Product Change Notice

Add ASE-M as a 2nd source Final Test site

BCM89811B1AWMLG
BCM89811B1AWMLGT
BCM89816B1AWMLG
BCM89816B1AWMLGT

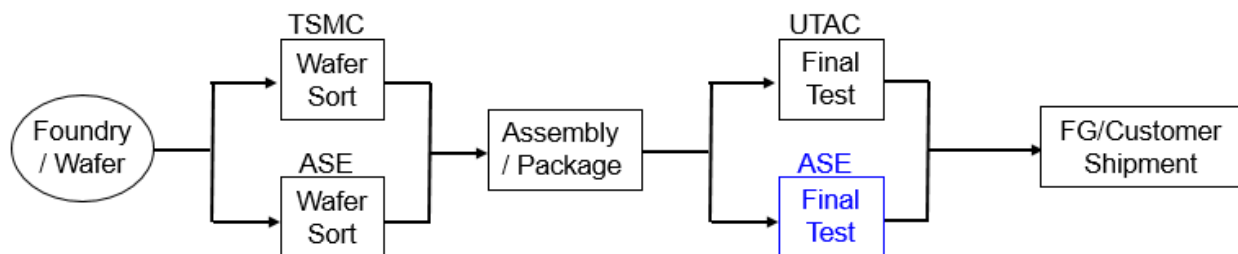
Electrical Final Testing (FT) is currently performed on this product at UTAC (Singapore). Broadcom will add ASE-M (Malaysia) as a 2nd source for FT. There is no change to the Foundry or Assembly locations or processes for this PCN – see updated flow below.
